Project Name: Flamingo Bay - 1110 North 6th Street - Teen Club

RE: Flamingo Bay at 1110 N. 6th St.

RE: Request for Building Permit Clearance at 1110 North 6th Street

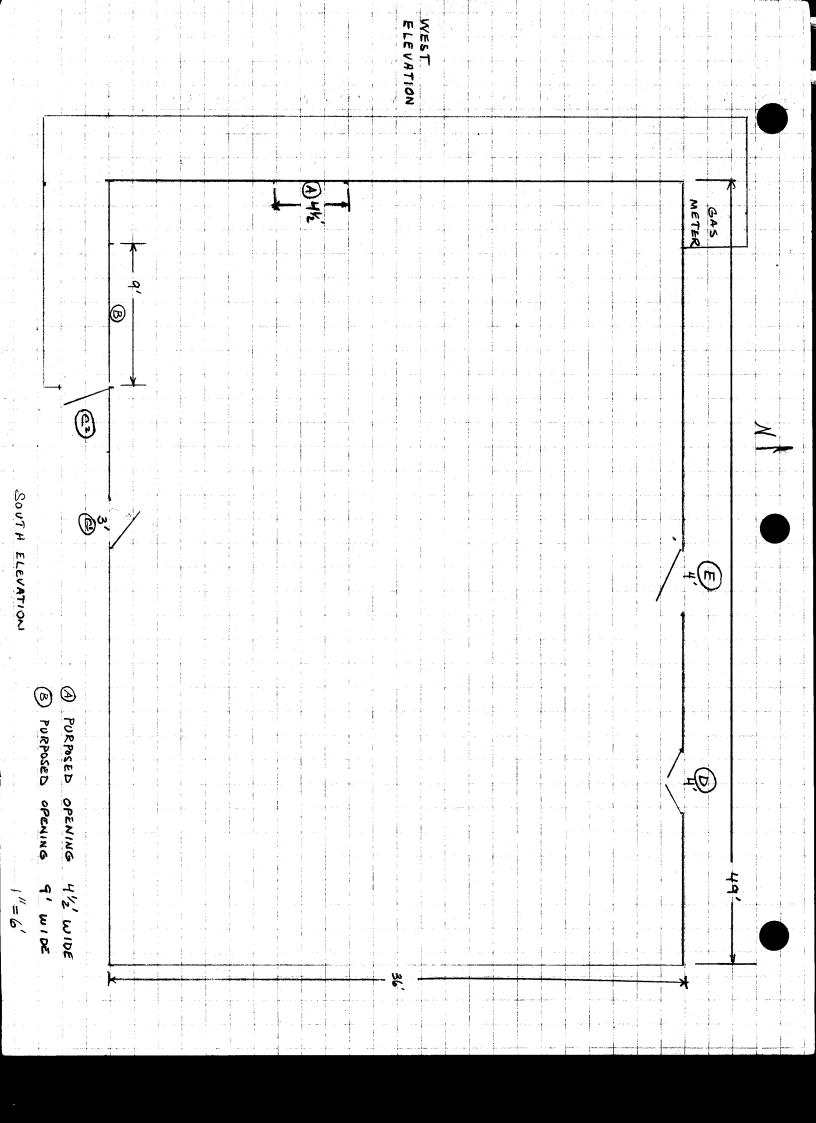
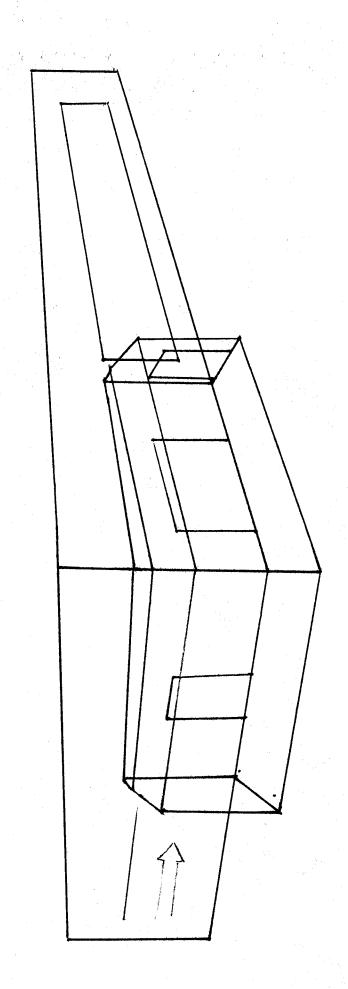
Your proposal as presented in the narrative titled "The Flamingo Bay Beach Club Outdoor Patio" dated July 27, 1988 and the attached site plan has been reviewed by this department. Although the proposal is an allowed use in the C-1 zone, there were other concerns that needed to be addressed.

Our major concern continues to be the off-street parking. The proposed patio will delete 18 of the spaces shown on the approved site plan for the Club. However, we understand this is a unique business as it relates to parking needs and that, thus far, is has not been a problem. The patio will be allowed with the condition that if parking becomes a problem the owner will take steps to alleviate it.

The other concern is the hours of operation and the noise generated from an outdoor facility. The developer should be aware the facility is near a residential neighborhood and should respect the residents by keeping the noise level to a minimum.

The C.O. will not be issued until the parking lot is restriped and the proper signage put up along Glenwood Avenue. All other concerns have been addressed through contacts with other businesses and departments.
